APPLICATION NO.	FILING DATE	FIRST NAMED INVENTOR	ATTORNEY DOCKET NO.	CONFIRMATION NO.	
10/643,198	08/18/2003	Manfred Schumacher	4965-000156	3660	
27572	7590	07/15/2004	EXAMINER		
HARNESS, DICKEY & PIERCE, P.L.C.				GANDHI, JAYPRAKASH N	
P.O. BOX 828				ART UNIT	
BLOOMFIELD HILLS, MI 48303				PAPER NUMBER	
				2125

Office Action Summary	Application No.	Applicant(s)	
	10/643,198	SCHUMACHER, MANFRED	
Examiner	Art Unit		
Jayprakash N Gandhi	2125

DETAILED ACTION

FIG. 3

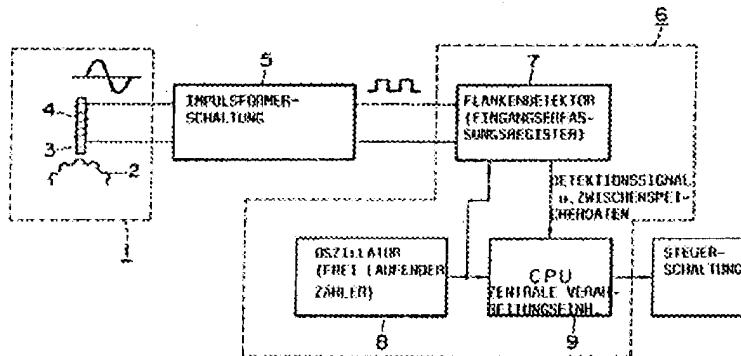
Regarding claims 1-6 and 12, DE discloses all the structure limitation of the press and device as shown in figure 3,

a pulse train signal derived from a rotation speed sensor mounted on the rotating body. The time is measured between the last pulse edge in the preceding reference time interval and the last pulse edge in the current reference time interval. The rotation speed is derived from the measured time interval. The number of speed measurement reference time intervals during which no pulse edges occur can be counted and the wheel speed set to null when the number of such intervals exceeds a defined threshold value, except of having shaft fracture monitoring for a press. It would have been obvious to one of ordinary skill in the art to use the structure of DE in the claimed application for monitoring shaft fracture monitoring,

further the claims are limited by and defined by the recited method, the determination of patentability of the product is based on the product itself, and does not depend on its method of production. If the product in the product-by-process claim is the same as or obvious from a product of the prior art, the claim is unpatentable even though the prior product was made by a different process. *In re Thorpe*, 227 USPQ 964, 966 (Fed. Cir. 1985).

Regarding claims 7-11, already modified structure of DE inherently possesses the method for failsafe monitoring of the rotational movement of the shaft.
